CAUSE NO. D-1-GN-24-007463

INDEX OF APPENDICES

LETTER APPROVAL OF WATER POLLUTION ABATEMENT
PLAN

Re: Approval of a Water Pollution Abatement Plan (WPAP)
Vulcan Comal Quarry; Located SW of FM 3009 and SH 46; Comal County, Texas
Edwards Aquifer Protection Program ID No. 13001906; Regulated Entity No.
RN111942793

Figure 3, Water Elevation in Wells Near Vulcan³¹

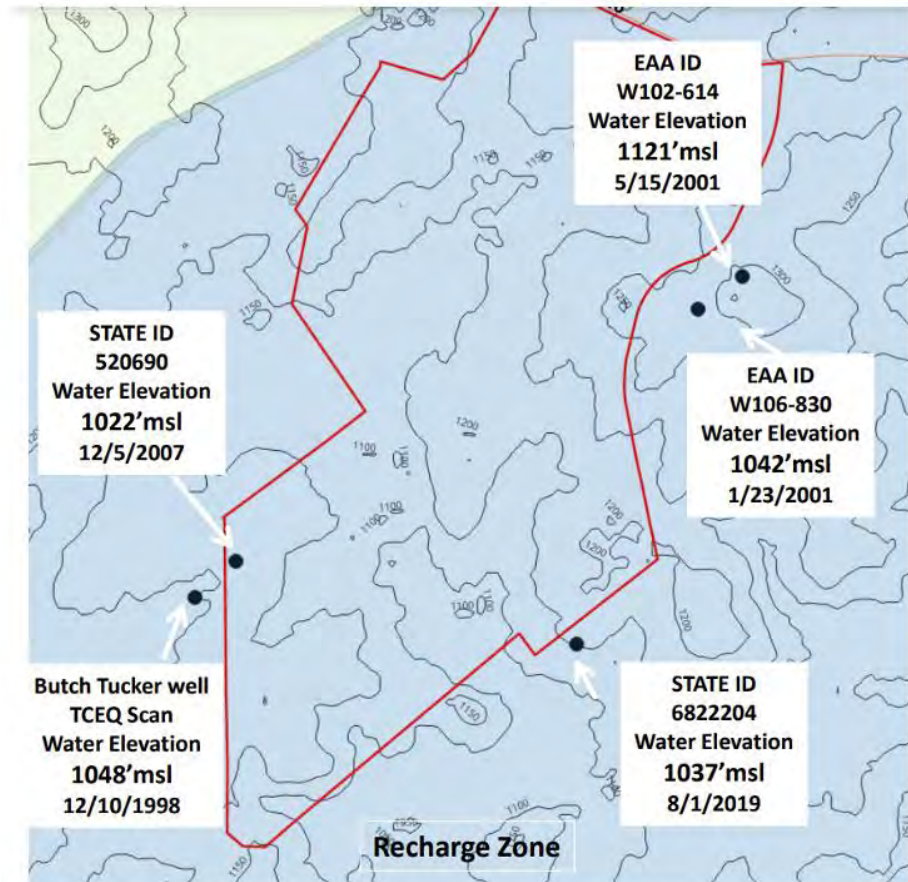
In fact, available water level data from several wells within 600 ft of the Vulcan property boundary shows water levels greater than 1022 ft-msl. *See* Figures 3 and 4 below.

Figure 6, Well Data with Nitrate Measurements above the TCEQ Ecological Screening Benchmark⁵¹

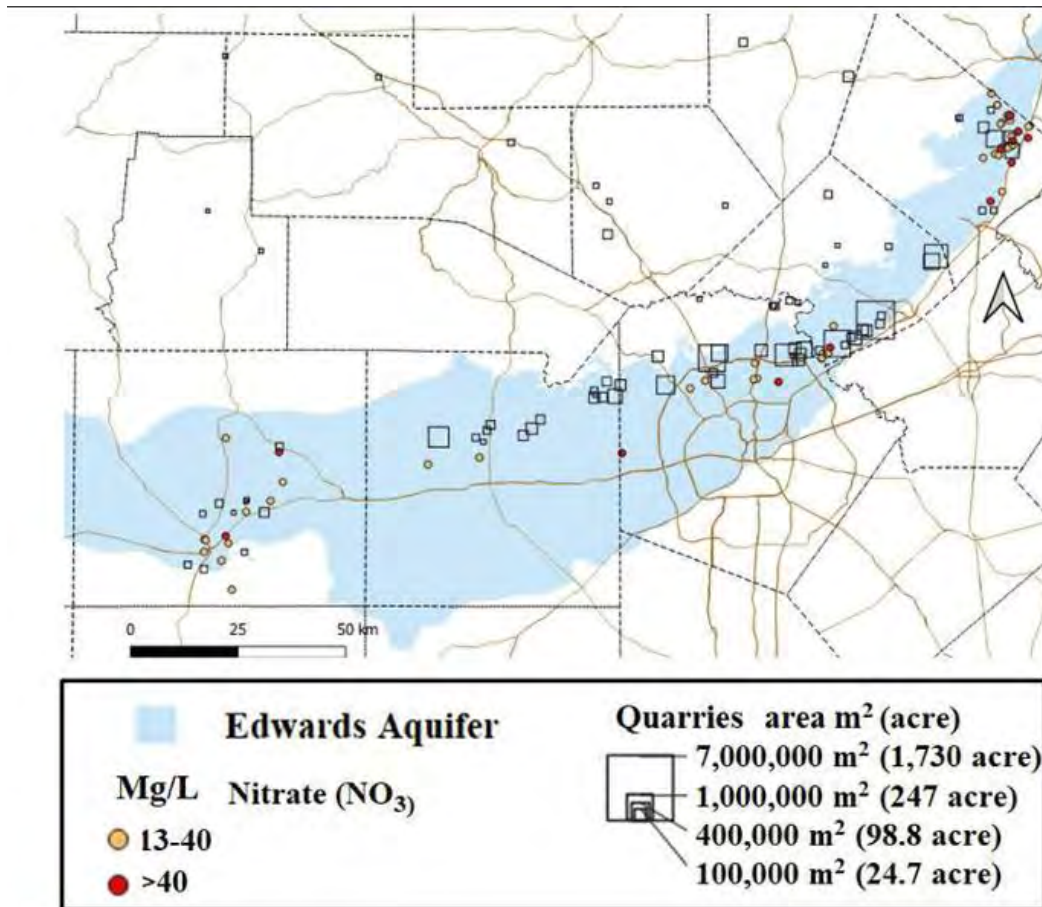
mg/L N as NO₃ (10 mg/L nitrate as N), 40 C.F.R. § 141.62(b)(7). The well data shown in Figure 6 below demonstrates that while nitrate observations above 40 mg/L in the Edwards Aquifer remain relatively rare, levels above 40 mg/L and above the TCEQ ecological screening benchmark tend to be relatively close to quarries. This suggests that well owners whose wells are unfavorably situated near quarries may experience degraded water quality.⁴⁷ Texas Water Company also owns wells near Vulcan, including 40 Trinity wells, which supply water to thousands of residents, including those in the nearby Vintage Oaks subdivision.⁴⁸ To determine background water-quality conditions, water-supply wells immediately downgradient of the quarry should be sampled and analyzed for nitrates and total petroleum hydrocarbons prior to issuing a permit for the quarry.⁴⁹ The Texas Water Company also submitted public comments asking that upon the commencement of any quarry activities a well monitoring program should be required to test for changes in water levels and contaminant levels.⁵⁰

Figure 9. Schematic cross section with estimated topography after mining and water levels based on available data (J. Finneran, personal communication, April 16, 2024).

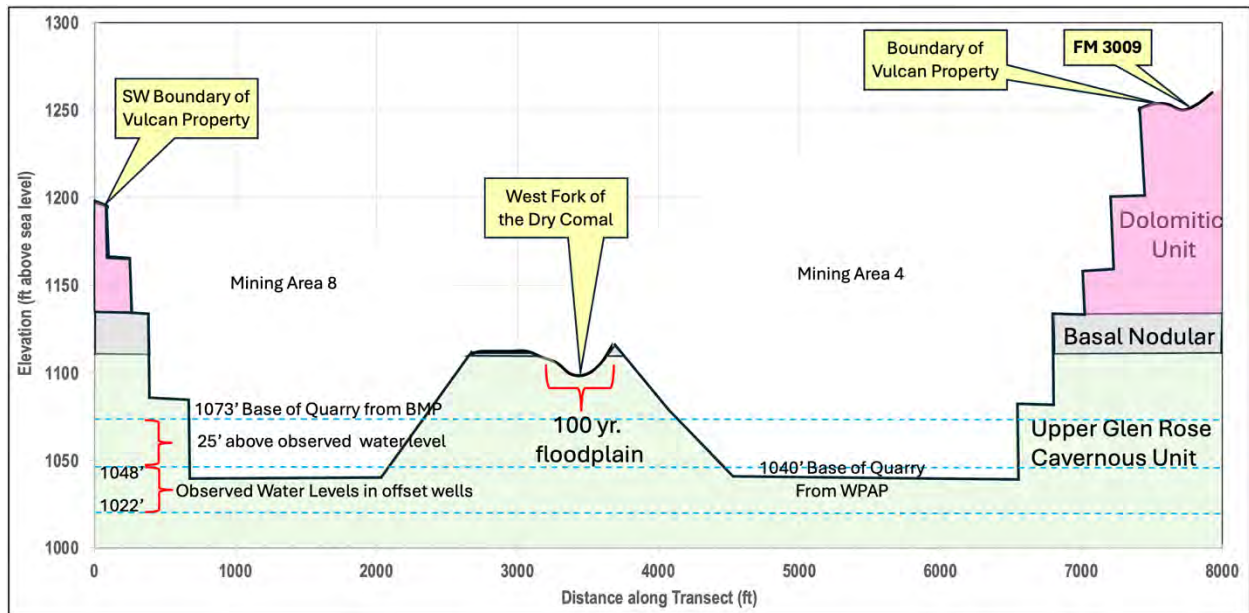
The WPAP (Pape-Dawson Engineers, 2024) for the site states that the mining areas will not be mined below an elevation of 1040 ft msl. According to the WPAP, this level of the quarry bottom will provide a 25-ft buffer above the high water level of the aquifer. A review of available water-level data indicates that at times, the bottom of the quarry will be flooded by the underlying aquifer (Figure 9). Water-level data from five wells close to the perimeter of the quarry boundary were evaluated to estimate expected water levels beneath the quarry and proposed depths of the excavations (Appendix B) (J. Finneran, personal communication, April 16, 2024). The White #4 well (#520690) had a water level of 1022 ft-msl on 12/5/07. At this water level plus the 25-ft buffer, the bottom of the quarry would be out of compliance. Another well (Tucker, EAA #Wxxx-137) had a water level of 1048 ft on 12/14/98. At this water level, the bottom of the quarry would be 8 ft below the water level in the aquifer.

Figure 9, Well Data with Nitrate Measurements above the TCEQ Ecological Screening Benchmark⁵³

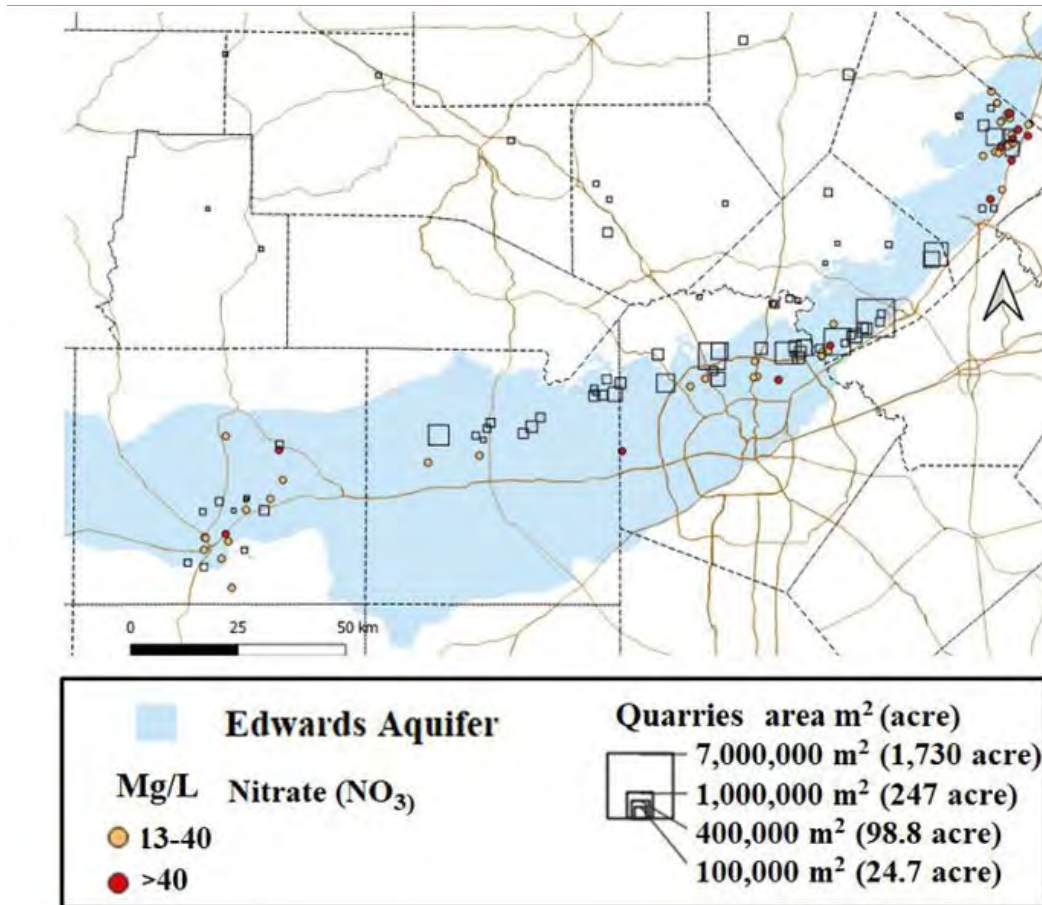
mg/L N as NO₃ (10 mg/L nitrate as N). 40 C.F.R. § 141.62(b)(7). The well data shown in Figure 9 below demonstrates that while nitrate observations above 40 mg/L in the Edwards Aquifer remain relatively rare, levels above 40 mg/L and above the TCEQ ecological screening benchmark tend to be relatively close to quarries. This suggests that well owners whose wells are unfavorably situated near quarries may experience degraded water quality.⁴⁹ Texas Water Company also owns wells near Vulcan, including 40 Trinity wells, which supply water to thousands of residents, including those in the nearby Vintage Oaks subdivision.⁵⁰ To determine background water-quality conditions, water-supply wells immediately downgradient of the quarry should be sampled and analyzed for nitrates and total petroleum hydrocarbons prior to issuing a permit for the quarry.⁵¹ The Texas Water Company also submitted public comments asking that upon the commencement of any quarry activities a well monitoring program should be required to test for changes in water levels and contaminant levels.⁵²

Figure 9. Schematic cross section with estimated topography after mining and water levels based on available data (J. Finneran, personal communication, April 16, 2024).

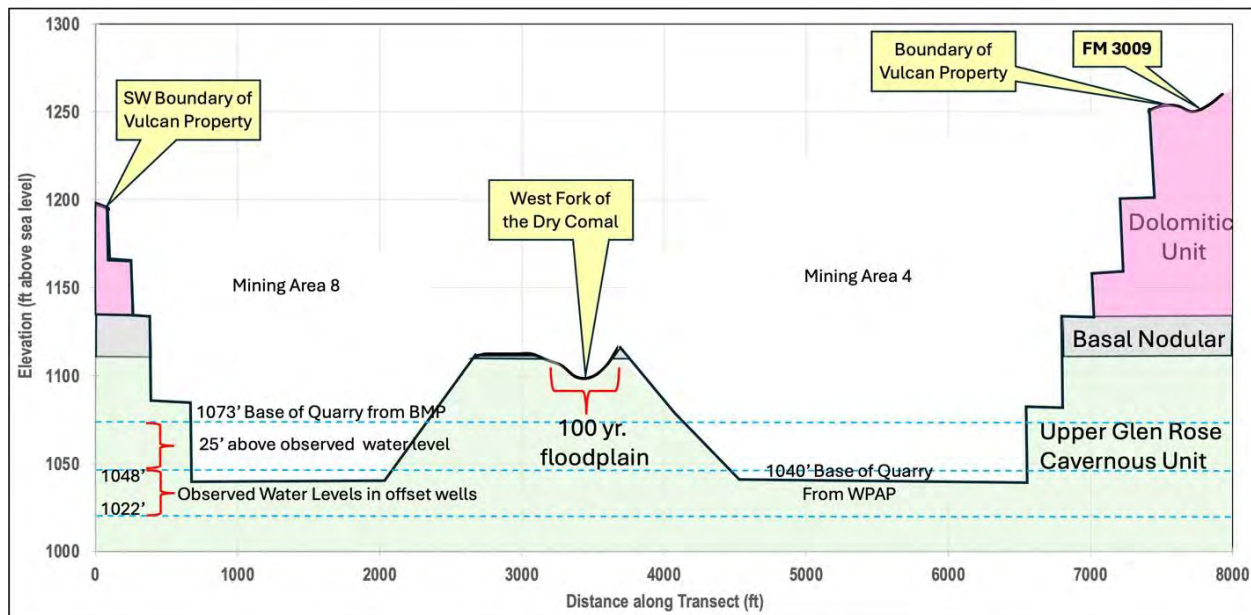
The WPAP (Pape-Dawson Engineers, 2024) for the site states that the mining areas will not be mined below an elevation of 1040 ft msl. According to the WPAP, this level of the quarry bottom will provide a 25-ft buder above the high water level of the aquifer. A review of available water-level data indicates that at times, the bottom of the quarry will be flooded by the underlying aquifer (Figure 9). Water-level data from five wells close to the perimeter of the quarry boundary were evaluated to estimate expected water levels beneath the quarry and proposed depths of the excavations (Appendix B) (J. Finneran, personal communication, April 16, 2024). The White #4 well (#520690) had a water level of 1022 ft-msl on 12/5/07. At this water level plus the 25-ft buder, the bottom of the quarry would be out of compliance. Another well (Tucker, EAA #Wxxx-137) had a water level of 1048 ft on 12/14/98. At this water level, the bottom of the quarry would be 8 ft below the water level in the aquifer.

Figure 9. Schematic cross section with estimated topography after mining and water levels based on available data (J. Finneran, personal communication, April 16, 2024).

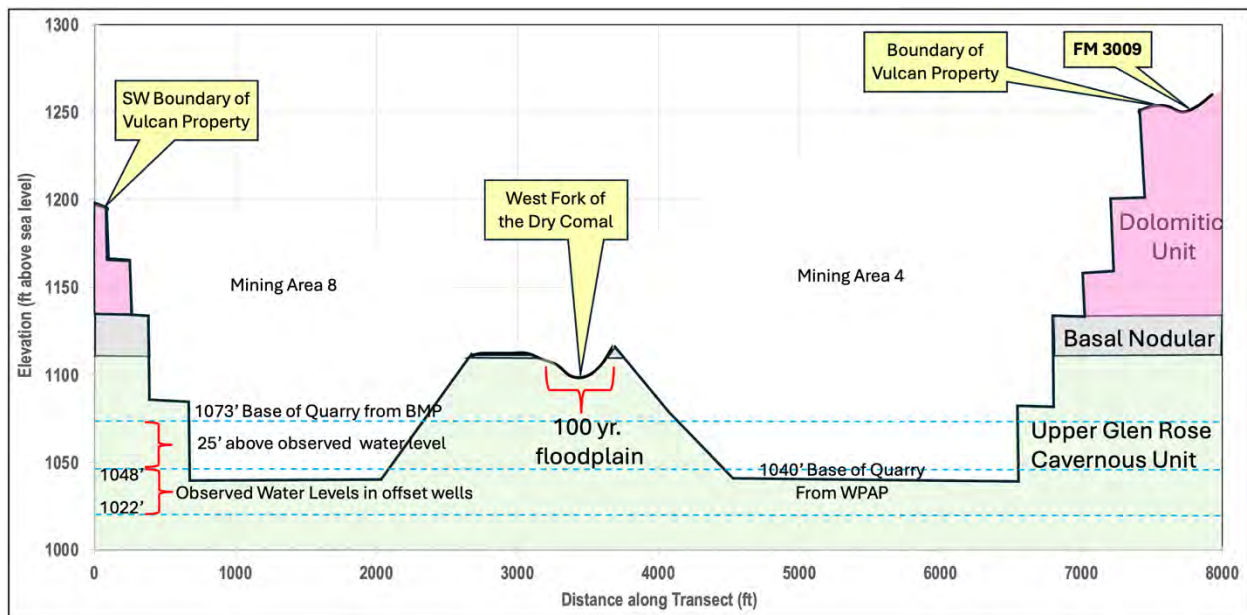
The WPAP (Pape-Dawson Engineers, 2024) for the site states that the mining areas will not be mined below an elevation of 1040 ft msl. According to the WPAP, this level of the quarry bottom will provide a 25-ft buffer above the high water level of the aquifer. A review of available water-level data indicates that at times, the bottom of the quarry will be flooded by the underlying aquifer (Figure 9). Water-level data from five wells close to the perimeter of the quarry boundary were evaluated to estimate expected water levels beneath the quarry and proposed depths of the excavations (Appendix B) (J. Finneran, personal communication, April 16, 2024). The White #4 well (#520690) had a water level of 1022 ft-msl on 12/5/07. At this water level plus the 25-ft buffer, the bottom of the quarry would be out of compliance. Another well (Tucker, EAA #Wxxx-137) had a water level of 1048 ft on 12/14/98. At this water level, the bottom of the quarry would be 8 ft below the water level in the aquifer.

Figure 1

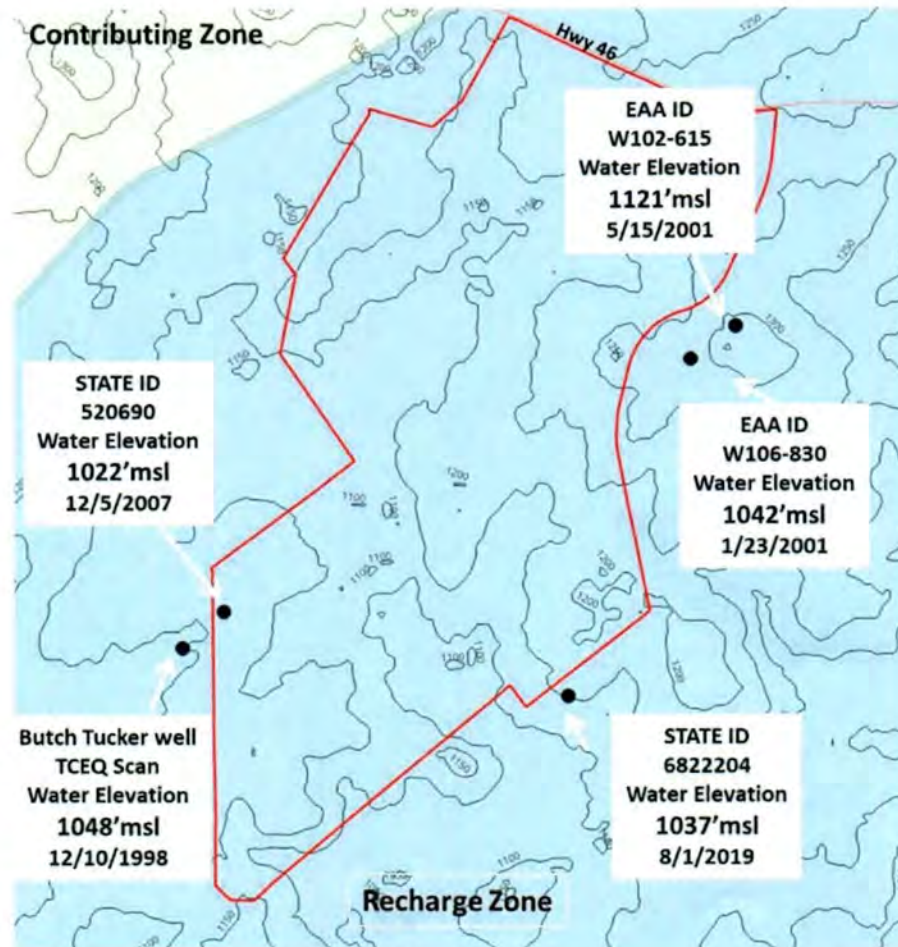
5. During my review of Vulcan’s WPAP, I analyzed the separation distance between the floor of the quarry and groundwater. The amended Application states that the Mining Areas will not be mined below 1047 feet-msl. I found that water level data from the Texas Water Development Board from several wells within 600 feet of the Vulcan property boundary shows water levels greater than 1022 ft-msl. I prepared a map showing the location of those wells which is labeled as **Figure 1**, below:

Figure 3

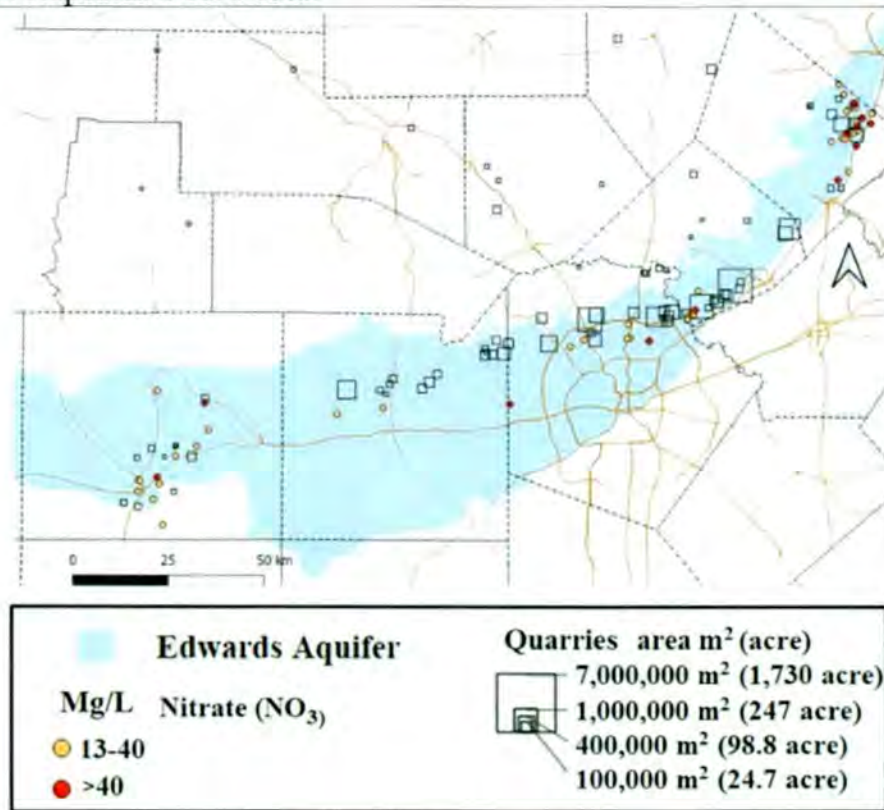
- contamination level (“MCL”) for drinking water at 40 mg/L N as NO₃ (10 mg/L nitrate as N). Texas Water Development Board well data demonstrate that while nitrate observations above 40 mg/L in the Edwards Aquifer remain relatively rare, levels above 40 mg/L and above the TCEQ ecological screening benchmark tend to be relatively close to quarries. This data is shown in the figure I prepared, which is labeled as **Figure 3** below, using an aquifer map from TCEQ, quarry locations from satellite imagery and Texas Water Development Board data:

- The data shown above in **Figure 3** suggest that well owners whose wells are unfavorably situated near quarries may experience degraded water quality.
- Depending on the concentration level, long term exposure to nitrate can be threatening to humans. In particular, prolonged exposure to nitrate levels above EPA’s maximum contamination level can cause blue-baby syndrome in infants, and pregnant women exposed to high nitrate concentrations may have babies with low birth weights. (Bryan Swistock, *Nitrates in Drinking Water*, PENNSTATE EXTENSION (updated Aug. 26, 2022)).
- Depending on the concentration level, long term exposure to nitrate can be threatening to aquatic organisms, which may have lower tolerances for nitrate

Figure 3. Abundant caves indicate the sensitivity of the area, and along with the density of karst feature mapped directly across highway 46 contrasts with the density of features mapped in the Vulcan site assessment.

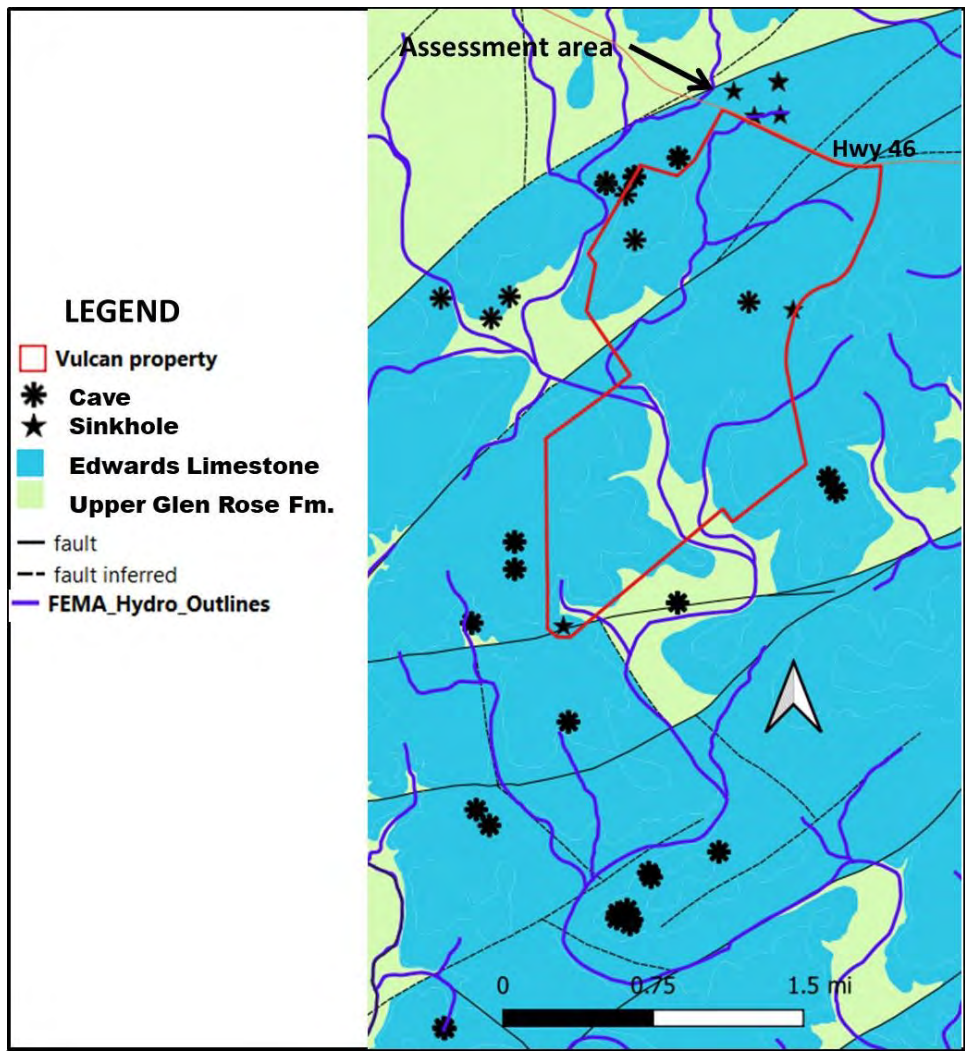
The site chosen for the Vulcan Comal Quarry is especially unsuitable for a quarry. Despite the claim in the WPAP that there is low potential for fluid migration into the aquifer, the abundance of caves in the vicinity show the area to be sensitive (Figure 3). Also, it should be noted that there is a subjective aspect to identifying sensitive features. The contrast in the density of features recorded at the Vulcan site and those recorded in a site assessment for a much smaller area directly on the other side of highway 46 suggests sensitive features on the Vulcan site may be undercounted.

Figure 4. One observed water elevation on the Vulcan property and four within a few hundred feet of the property demonstrate that the water levels in the area repeatedly reach elevations that would put Vulcan's desired elevation for the base of the quarry in violation of the TCEQ BMP.

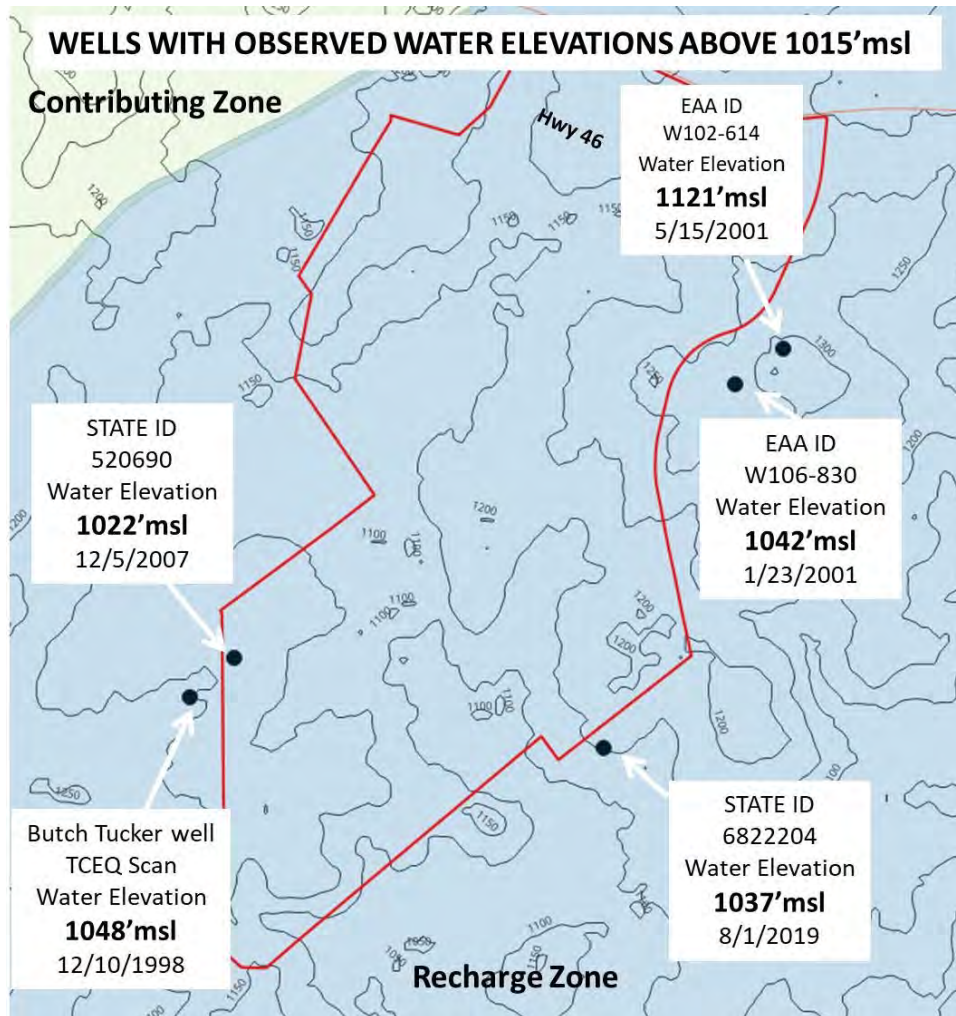
varying precipitation for the next 64-96 years. For the 1040' msl quarry base to be compliance with the TCEQ BMP, the highest elevation expected for the aquifer would have to be no higher than 1015' msl. In fact, five wells already drilled on or within several hundred feet of the property document different times over a 21 year span when a 1040' msl quarry base would have violated the TCEQ BMP (Figure 4). Three of those wells the recorded aquifer elevations above 1040' msl. Well monitoring would have value if its purpose is to monitor contaminant concentrations. Water level monitoring might allow mining activity to stop when level approaches 1015' msl, but if the 1040' msl level has already been reached in parts of the quarry, those areas will flood. The only thing that can be stated factually is that if Vulcan had been allowed to start this project in 1990 we would have already seen the quarry floor in excavated areas flood three times. Each time would bring the aquifer directly into contact with nitrate and other contaminants accumulated there. It is unlikely that the five wells drilled at random dates have actually identified the maximum possible elevation, and there is no reason to think the aquifer will not
